EXPLODED VIEW, PARTS AND PRICE LIST Model 1400 & 140

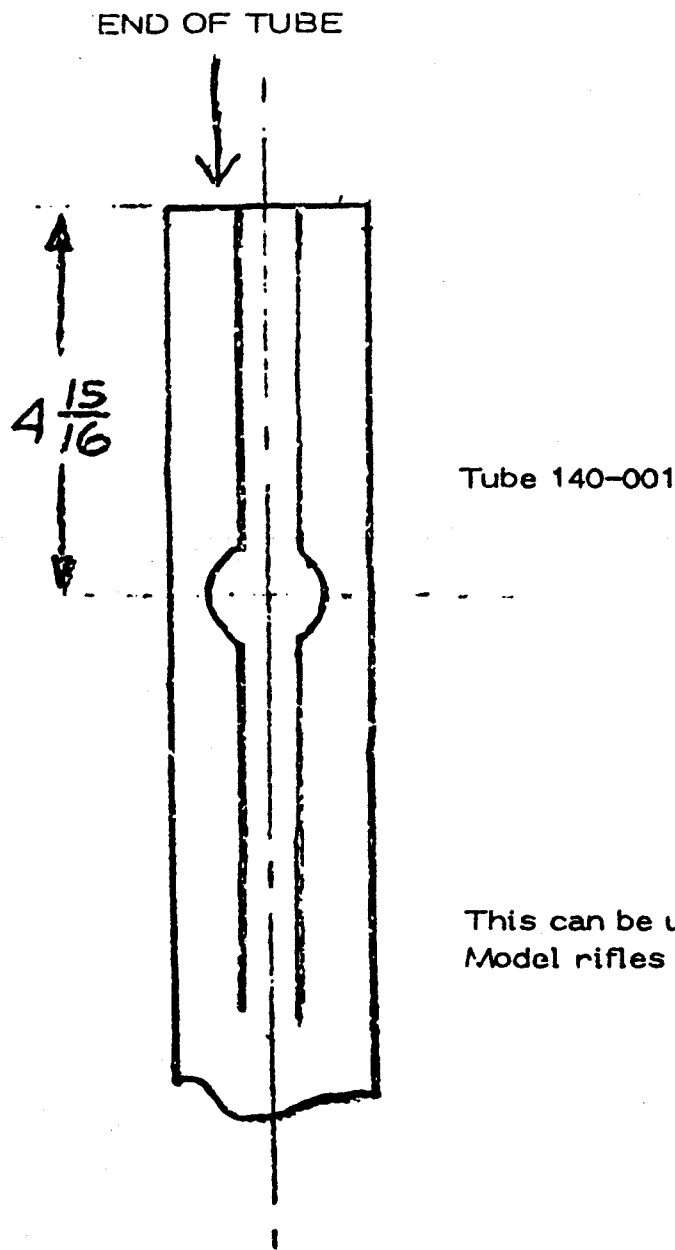
The 140-074 Lever & Link Assy is no longer available. We have replaced this with the 1400-014 Lever & Link Assy. This Assy consists of a larger Lever Link Rivet. In order to do this the lever slot has to be filed or milled out to accept the larger rivet. The drawing above will help you locate the point to mill or file tube slot.
